**ADDENDUM NUMBER 1**  
**PROJECT CODE: A0122-21-492426 and A0135-22-511452**  
**IFB# 154542103**

**November 11, 2021**

PROJECT: Virginia Tech  
New Baseball Pitching Lab  
Blacksburg, Virginia

# NYLOPLAST TURF TRAFFIC INSTALLATION

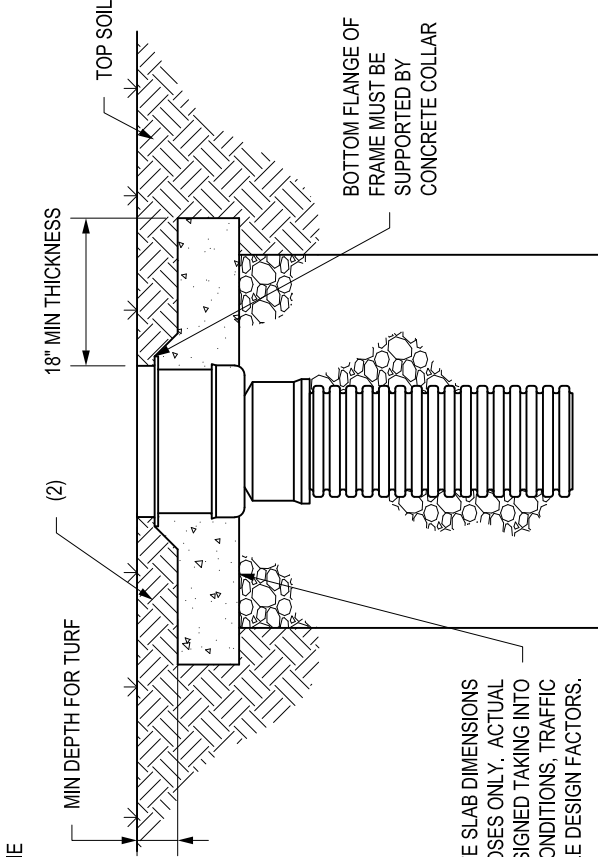
**C2.1, SITE LAYOUT AND DIMENSION PLAN:**

**REVISE** note #3 to read:

Yard Drains – The 12" Yard Drains shown around the building (numbered 25.1 through 25.10) shall be Nyloplast 12" Drain Basins or Nyloplast 12" Inline Drains (per attached detail Nyloplast Turf Traffic Installation), supported by a concrete collar, using a Pedestrian Grate, with the sump filled with Nyloplast Plug or concrete to the invert out.
